SUBJECT: ISSUANCE OF AMENDMENT NO.176FOR TSCR NO. 207 (TAC NO. M86085)

THREE MILE ISLAND NUCLEAR STATION, UNIT NO. 1

Amendment No. 176
License No. DPR-50

SAFETY EVALUATION BY THE OFFICE OF NUCLEAR REACTOR REGULATION
RELATED TO AMENDMENT NO. 176 TO FACILITY OPERATING LICENSE NO. DPR-50

Figure 3.1-1 Reactor Coolant System Heatup/Cooldown Limitations

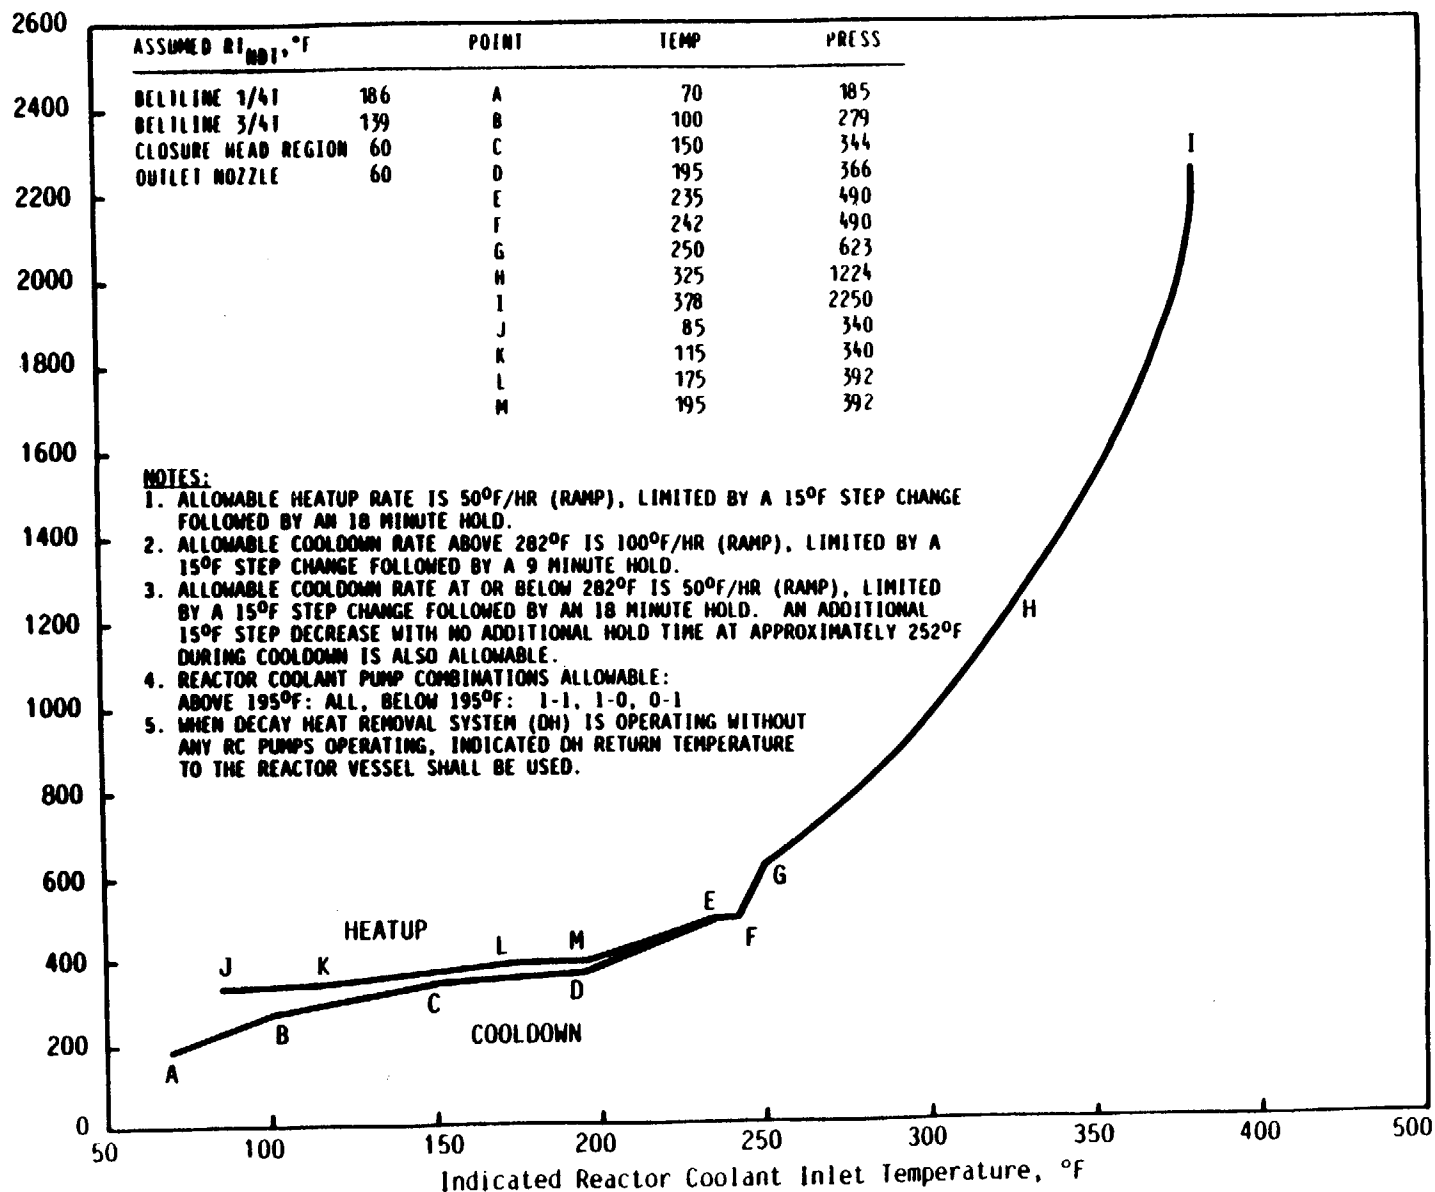
The amendment extends the effectiveness of the Technical Specification (TS) pressure vs. temperature limits until plant operation has reached 15.2 effective full power years (EFPY). The original TS Change Request proposed extending these limits (TS Figures 3.1-1 and 3.1-2) to 32 EFPY corresponding to the end of the license period. However, in a series of conference calls with your Headquarters staff at Parsippany, the NRC technical staff raised a number of questions regarding the methodology and data to be used in calculating the adjusted reference temperature. The methodology proposed by GPU Nuclear is somewhat different than that prescribed in Regulatory Guide 1.99, Revision 2, "Radiation Embrittlement of Reactor Vessel Materials." There are ongoing evaluations of reactor vessel integrity in conjunction with Generic Letter 92-01 that will not be completed until 1994. Therefore, the NRC staff is not yet in a position to accept this modified approach. However, the staff does find that the present limits are acceptable to at least 15.2 EFPY.

Allowable combinations of pressure and temperature shall be to the right of and below the limit line in Figure 3.1-1. Heatup and cooldown rates shall not exceed those shown on Figure 3.1-1.

To evaluate the P-T limits, the NRC staff performed calculations to determine the EFPY that corresponds to the limiting ART of 186°F in the current P-T limits using RG 1.99, Rev. 2.

Based on RG 1.99, the staff calculated the chemistry factor for weld WF-25 to be 219.4°F using surveillance data from TMI Unit 1 and other reactor vessels that have the same weld metal (Table 2). The staff used a margin of 50°F which was determined based on a sigma I of 20.6°F and sigma delta of 14°F. Based on the above parameters (chemistry factor, initial RT_{NDT} , and margin), the staff determined that an ART of 186°F corresponds to 15.2 EFPY of TMI-1 operation. Substituting the ART of 186°F into SRP 5.3.2., the staff determined that the P-T limits satisfy Sections IV.A.2 & IV.A.3 of Appendix G to 10 CFR 50.

The staff has determined that the current P-T limits for heatup, cooldown, and inservice leak and hydrostatic test are valid for 15.2 EFPY. The staff's evaluation included performing independent calculations using RG 1.99, Rev. 2 and SRP 5.3.2. The staff concludes that the proposed changes to the current P-T limits may be incorporated in the TMI Unit 1 Technical Specifications.

- 3.1.2.1 For operations until 15.2 effective full power years, the reactor coolant pressure and the system heatup and cooldown rates (with the exception of the pressurizer) shall be limited in accordance with Figure 3.1-1 and Figure 3.1-2 and are as follows:

- 3.1.2.4 Prior to exceeding 15.2 effective full power years of operation, Figures 3.1-1 and 3.1-2 shall be updated for the next service period in accordance with 10 CFR 50, Appendix G, Section V.B. The highest predicted adjusted reference temperature of all the beltline materials shall be used to determine the adjusted reference temperature at the end of the service period. The basis for this prediction shall be submitted for NRC staff review in accordance with Specification 3.1.2.5.

Figure 3.1-2 Reactor Coolant Inservice Leak and Hydrostatic Test
(Applicable through 15.2 EFPY)

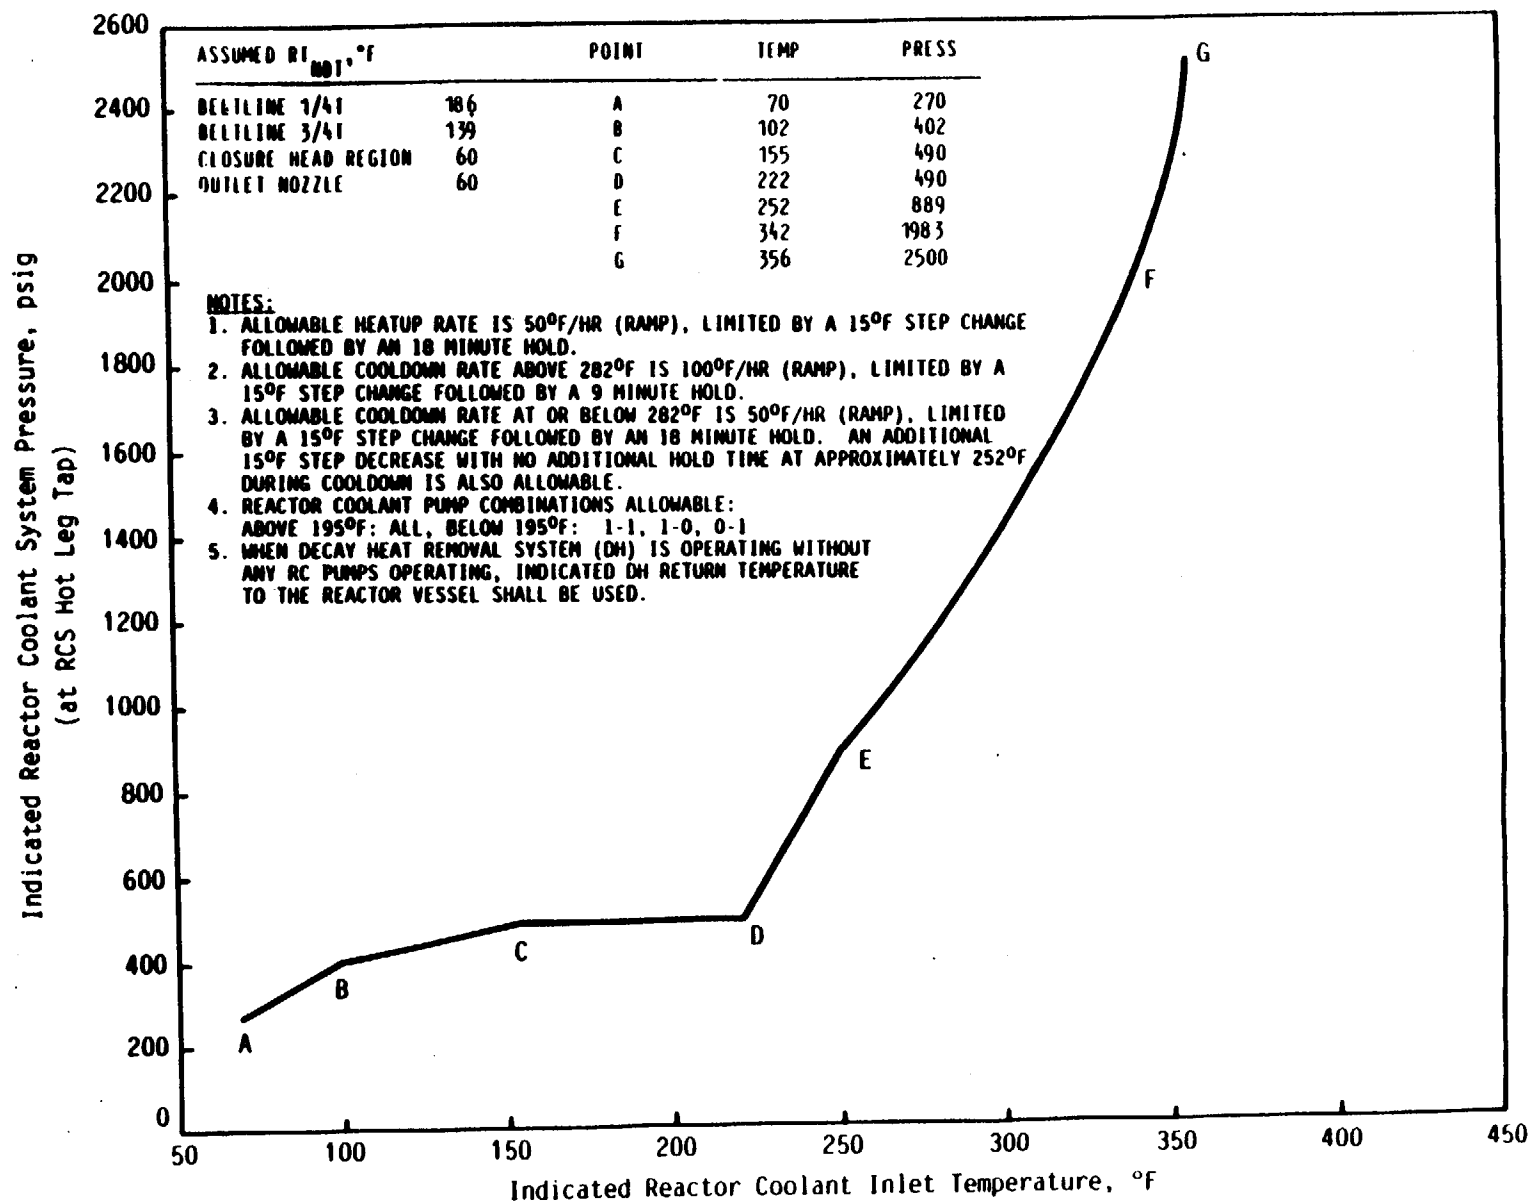
Allowable combinations of pressure and temperature shall be to the right of and below the limit line in Figure 3.1-2. Heatup and cooldown rates shall not exceed those shown on Figure 3.1-2.
